DESIGN <i>KE</i>	DRAWN BY <i>CP</i>	DART AEROSPACE LTD HAWKESBURY, ONTARIO, CANADA	
CHECKED <i>KE</i>	APPROVED <i>[Signature]</i>	DRAWING NO. DEO 9121	REV. A SHEET 1 OF 1
DATE 98.12.11		TITLE END PLATE CHANGE	SCALE NTS
A	98.12.11	NEW ISSUE

DART ENGINEERING ORDER

AMEND DRAWING D2678 REV. B

**FIGURE 1**

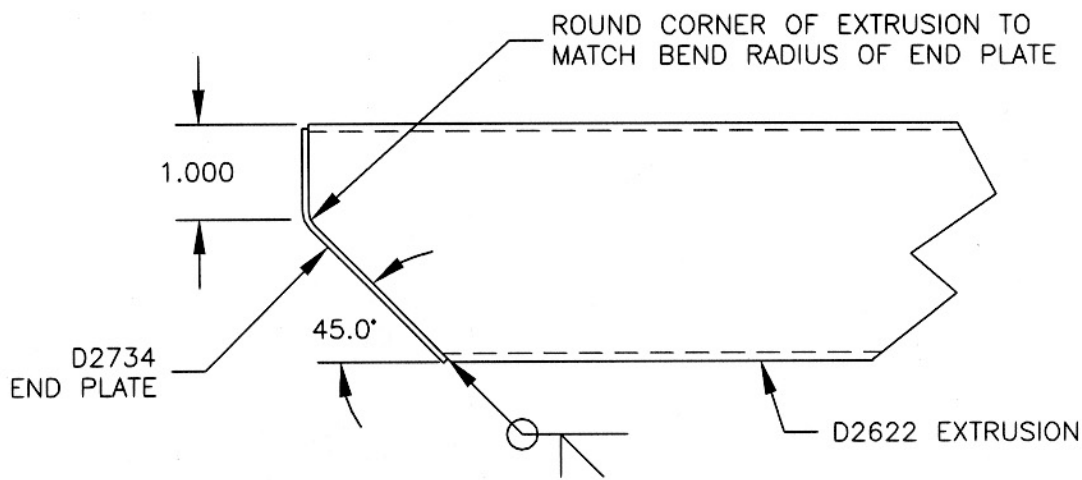
- (2) REPLACE REFERENCE TO D2669-45 ON PAGES 2 AND 4 WITH D2734
- (3) MAINTAIN OVERALL EXTRUSION CUT LENGTH OF 104.45
- (4) CUT AFT END OF D2622 EXTRUSION AS SHOWN BELOW IN FIGURE 1.
- (5) INSTALL D2734 END PLATE AS SHOWN BELOW IN FIGURE 1. WELD PER DART QSI 004.
